Access Compliance Report Public Rights-of-Way (Island Curb Cuts)

Intersection ID: 10036062 Main Street: RIVERGATE PY **Cross Street: N/A** Location: SE ADA ID: E0C65F8B9ACC Curb Cut Type: MedianRefuge2 Initial Pass/Fail: Fail **Overall Compliance: No** Severity Score: 8.75

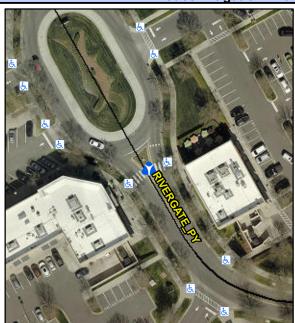
Yes	Refuge 1 Slope (%)	1.6	N/A	Gutter 1 Slope (%)	N/A
Yes	Refuge 1 X Slope (%)	2.2	N/A	Gutter 1 X Slope (%)	N/A
N/A	Painted X Walk1?	Yes	N/A	DWS 1 Provided?	N/A
N/A	X Walk 1 Direction	To SW	N/A	DWS 1 Contrast?	N/A
N/A	X Walk 1 Width (In)	121.0	N/A	DWS 1 Length (In)	N/A
N/A	Road 1 Slope (%)	2.6	N/A	DWS 1 Full Width?	N/A
N/A	Road 1 X Slope (%)	0.9	N/A	DWS 1 Offset (In)	N/A
No	Refuge 2 Length (In)	35.5	N/A	Gutter 2 Ponding?	N/A
No	Refuge 2 Width (In)	51.0	N/A	Gutter 2 Lip Ht (In)	N/A
Yes	Refuge 2 Slope (%)	1.6	N/A	Gutter 2 Slope (%)	N/A
Yes	Refuge 2 X Slope (%)	1.4	N/A	Gutter 2 X Slope (%)	N/A
N/A	Painted X Walk2?	Yes	N/A	DWS 2 Provided?	N/A
N/A	X Walk 2 Direction	To NE	N/A	DWS 2 Contrast?	N/A
N/A	X Walk 2 Width (In)	120.0	N/A	DWS 2 Length (In)	N/A
N/A	Road 2 Slope (%)	2.9	N/A	DWS 2 Full Width?	N/A
N/A	Road 2 X Slope (%)	1.6	N/A	DWS 2 Offset (In)	N/A
N/A	Refuge 3 Length (in)	N/A	N/A	Gutter 3 Ponding?	N/A
N/A	Refuge 3 Width (in)	N/A	N/A	Gutter 3 Lip Ht (in)	N/A

Remove & Replace Entire Refuge.
